12 August 2011

# Section 75W modification to the Huskisson Hotel Redevelopment Owen Street, Huskisson

# **Attachment 1**

Temporary car park for Stage 1

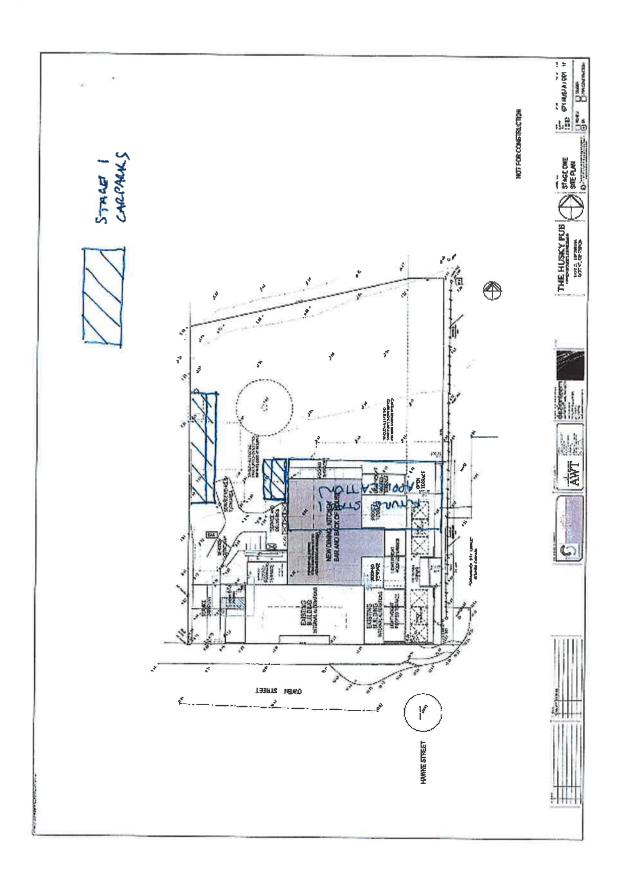
The Commission raised the issue of temporary parking for Stage 1 with the proponent at the meeting. The proponent by letter dated 12 July 2011 agreed to provide 12 temporary parking spaces in Stage 1 of the project (see Attachment 1). The Commission includes this as a condition of approval.

As discussed yesterday I confirm that Kamsley Pty Lamited (the Applicant) will include 12 car parks in Stage 1 of the project. These car parks will be surface car parks located in the North West section of the site. The attached drawing notes the indicative location of the rar parks.

- 4. Condition B22 add a third (3<sup>rd</sup>) paragraph to Condition 22 as follows:
  - Twelve (12) temporary parking spaces shall be provided at the location indicated on the Plan shown in Attachment 1 of this report. The parking spaces should be available for patrons to the hotel at the completion of Stage 1 until the completion of Stage 2.
- 5. Conditions B24 and B31 retained in Part B prior to the issue of construction certificate.
- **6.** Removal of recommended conditions E19 and E20 and renumber the subsequent conditions.

Twelve (12) temporary parking spaces shall be provided at the location indicated on the Plan shown in Schedule 3. The parking spaces shall be available for the use of hotel patrons' at the completion of Stage 1 until the commencement of Stage 2.
